ADDENDUM NO. 02

TO: PLANS AND SPECIFICATIONS FOR STATE OF MISSOURI

Interior and Exterior Repairs and Improvements
Missouri State Highway Patrol Hangar
Jefferson City Memorial Airport, Missouri
Project No.: R2007-01

D-101

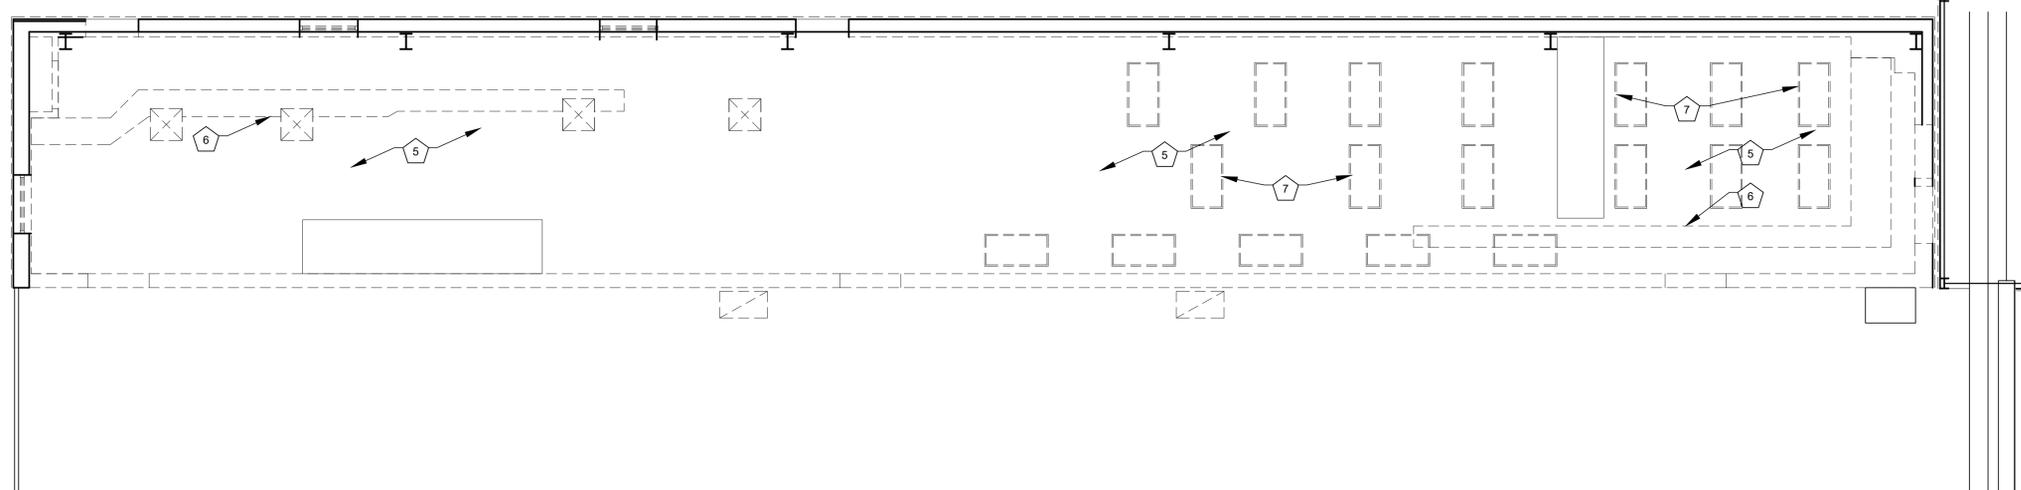
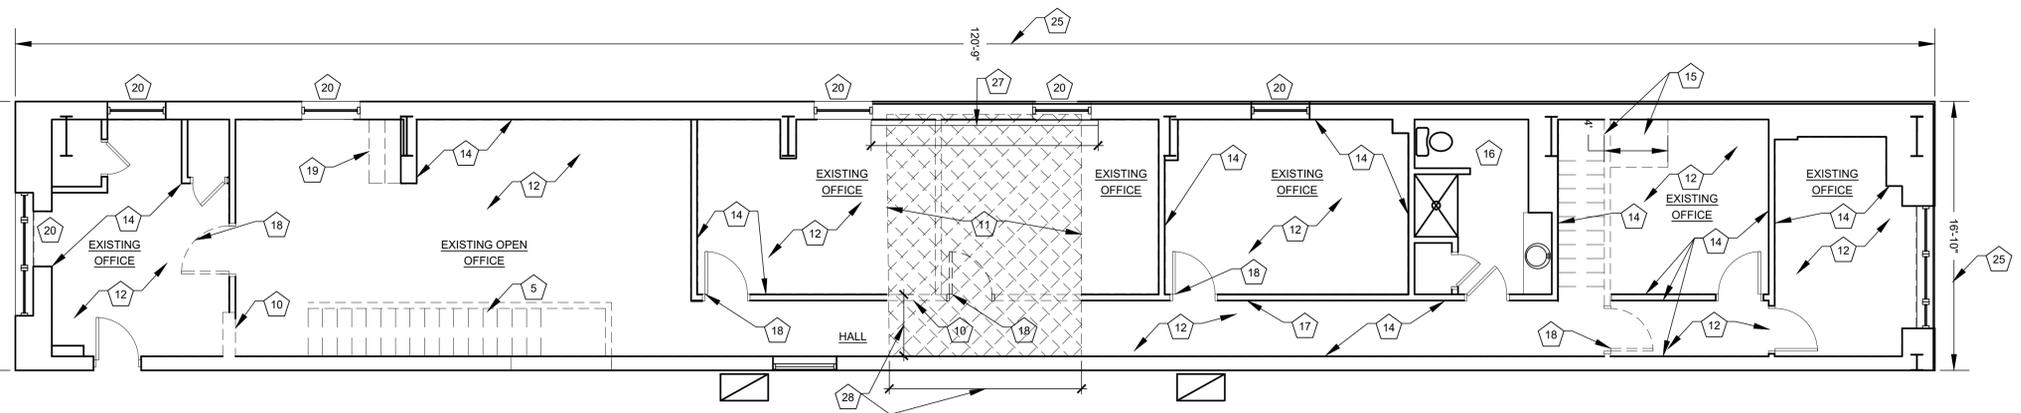
2. **ADD Interior Construction Barriers:** The Contractor shall construct a movable, self-supporting safety fence/barrier (not attached to floor or building structure) within the Hanger Area to separate the Contractor working/material storage area and the Owner-occupied area for maintenance. The fence/barrier should be no less than 4 feet tall and no more than 5 feet tall with appropriate warning designations (warning colors with text or similar) for building users. The Contractor shall maintain and coordinate the location of this barrier with the Owner throughout the construction operations. Reference D-101 note 30 for extent of construction barrier and its approximate location.

A-100

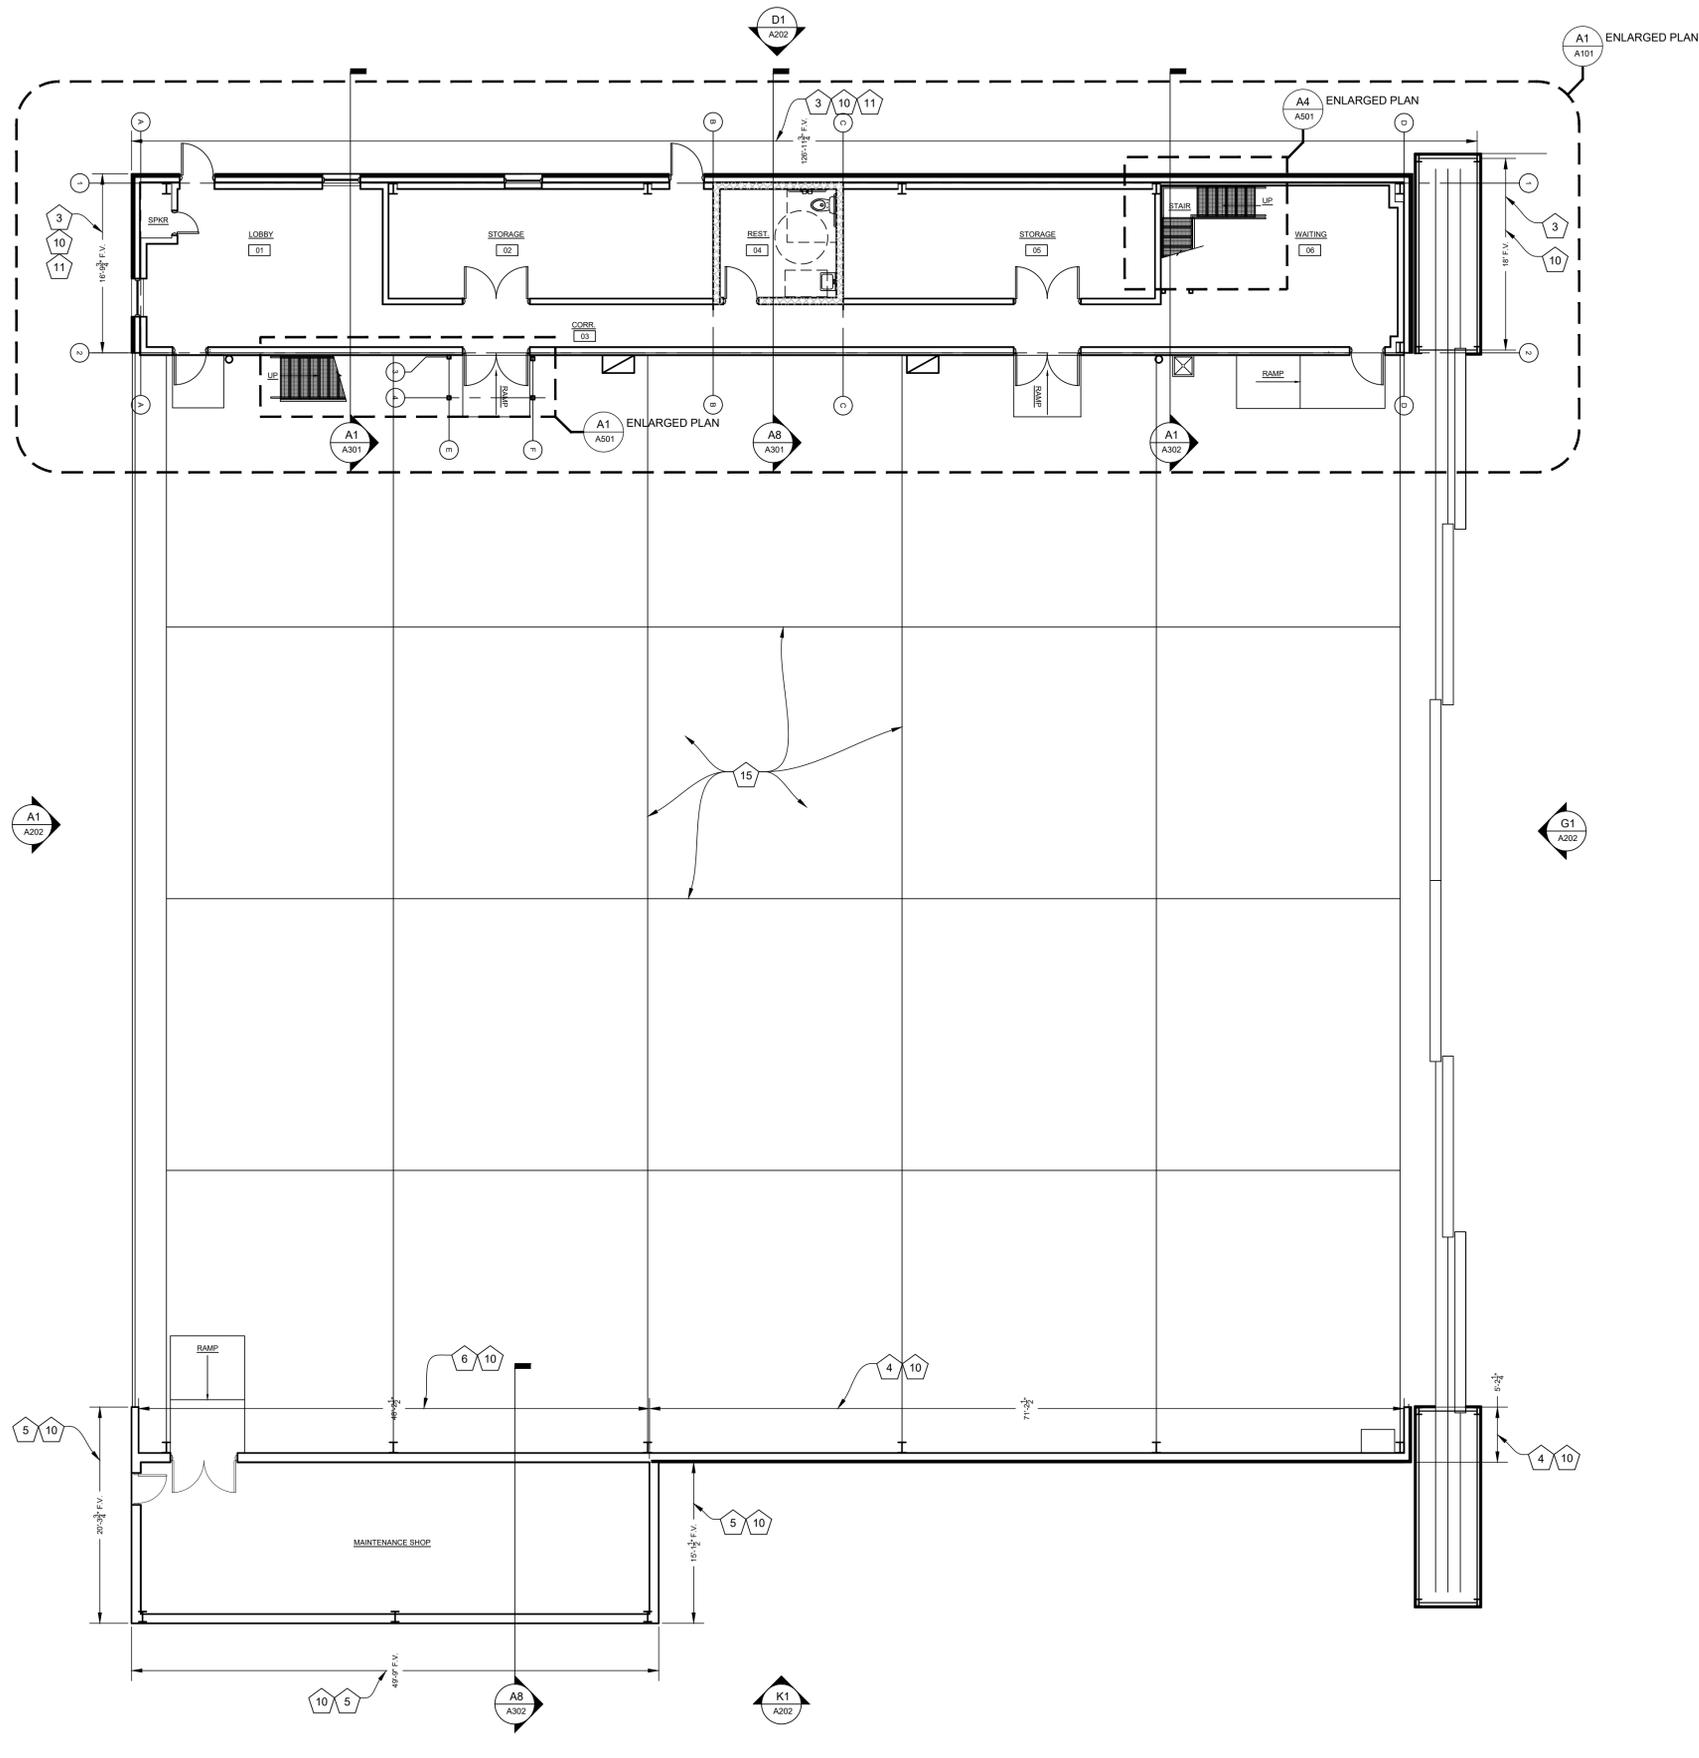
1. **Drawing A-100**
 - a. REVISE Scope of Work Notes 5 and 10.
 - b. REVISE description of Alternate #2 in alternate scope of work notes.
2. **Drawing A-101**

A-101

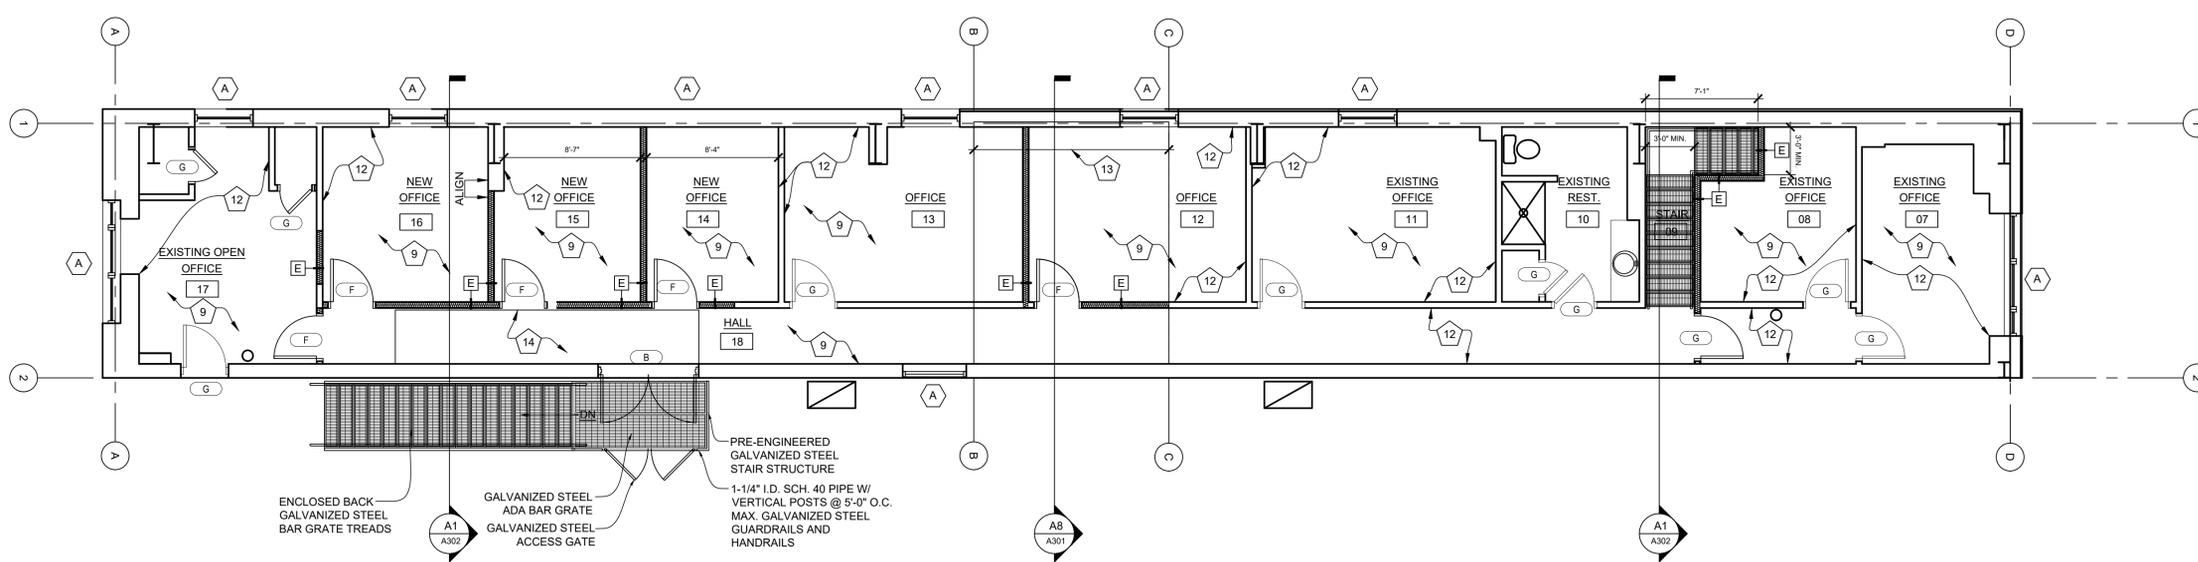
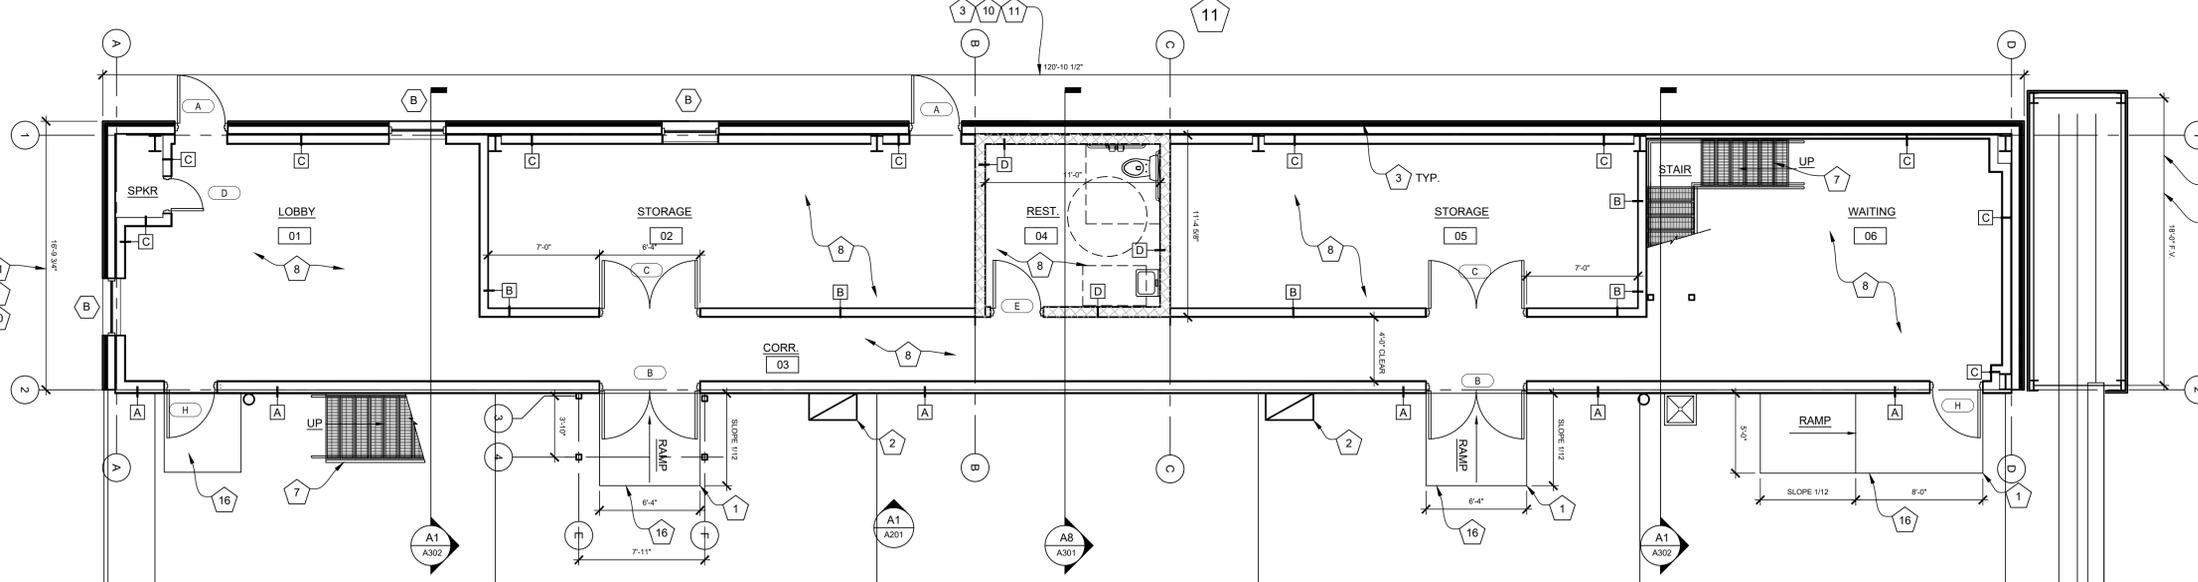
- a. REVISE Scope of Work Notes 5 and 10.
 - b. REVISE description of Alternate #2 in alternate scope of work notes.
3. **Drawing A-102**
 - a. MOVE scope of work note bullet 4 on detail H1 for legibility.

H1 REFLECTED CEILING PLAN - MAINTENANCE SHOP
SCALE: 3/16" = 1'-0"

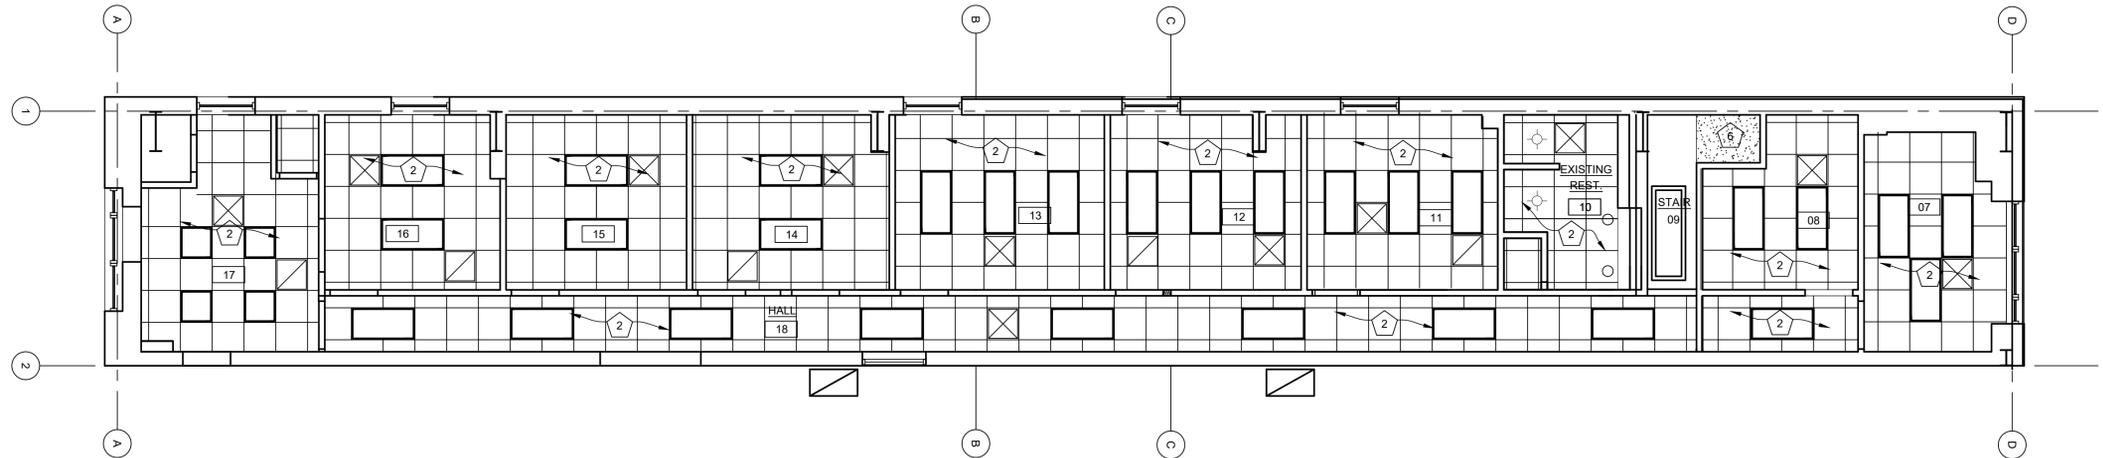
- b. REVISE description of Alternate #2 in alternate scope of work notes.
4. **Drawing A-201**
 - a. REVISE Scope of Work Notes 5 and 10.
 - b. REVISE description of Alternate #2 in alternate scope of work notes.

A-201

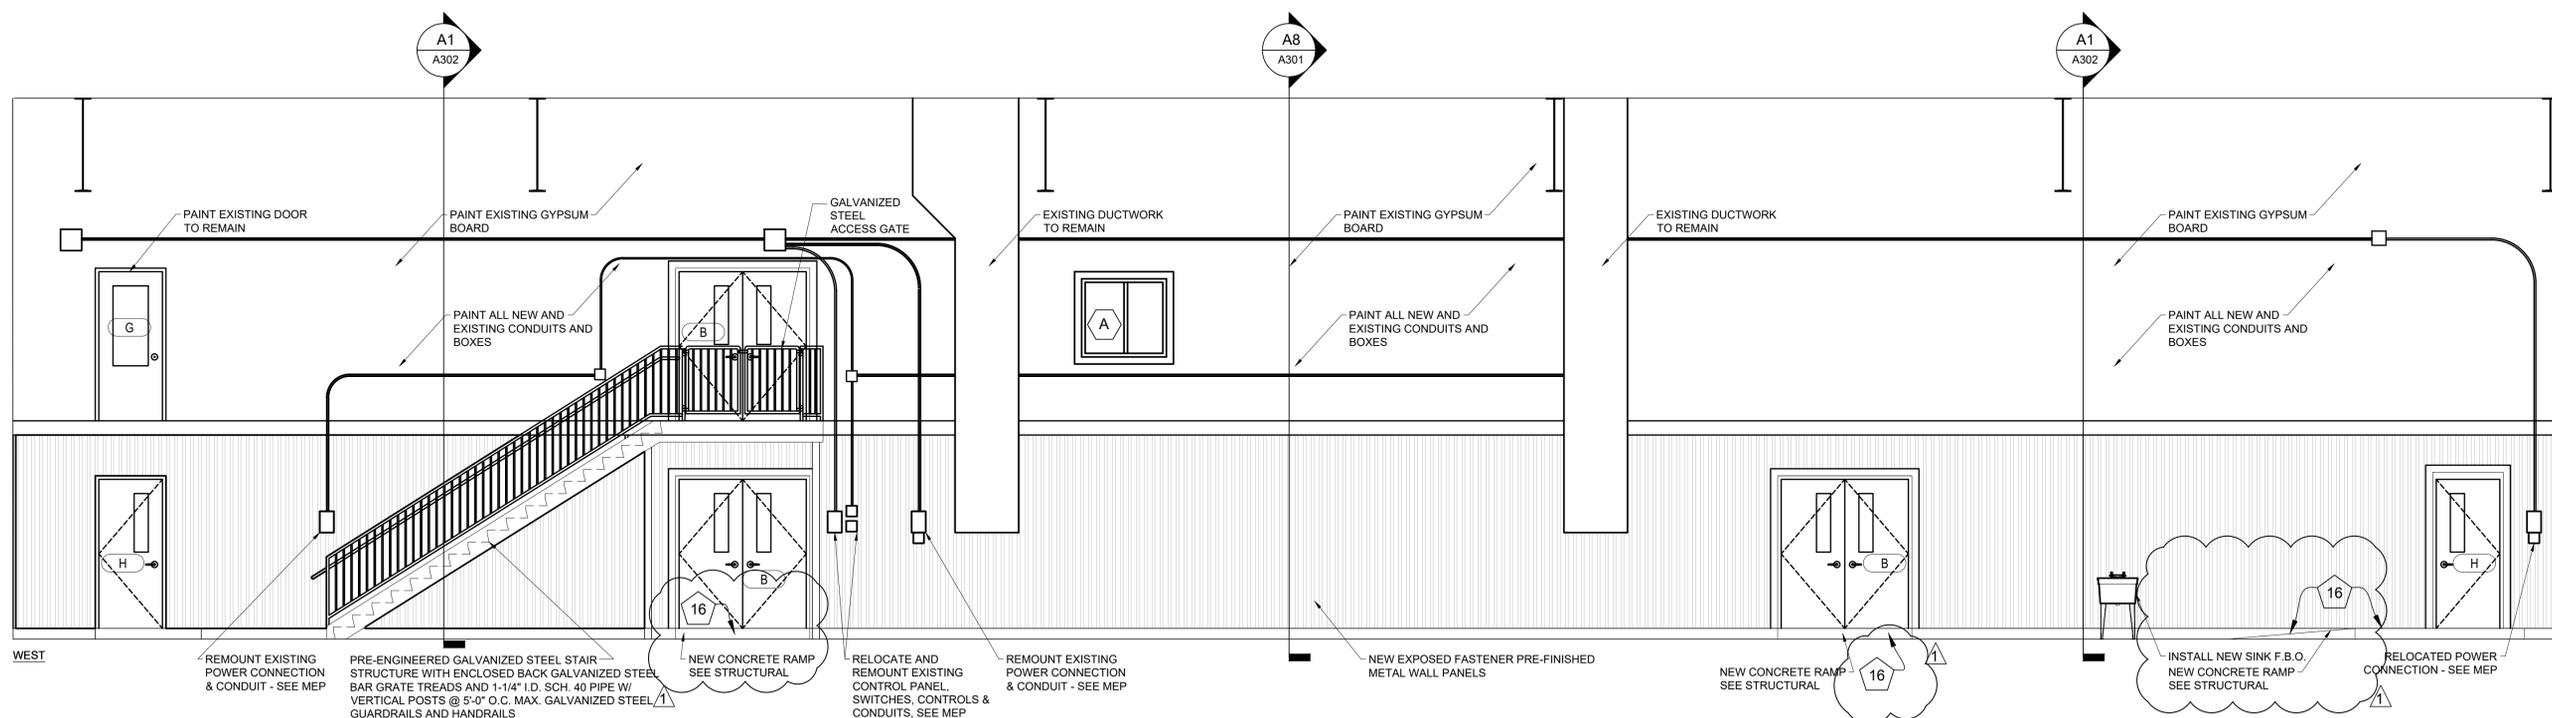
- c. ADD Note bullets 16 in detail A-Interior Elevations.
5. **Drawing A-202**
 - a. REVISE Scope of Work Notes 5 and 10.
 - b. REVISE description of Alternate #2 in alternate scope of work notes.
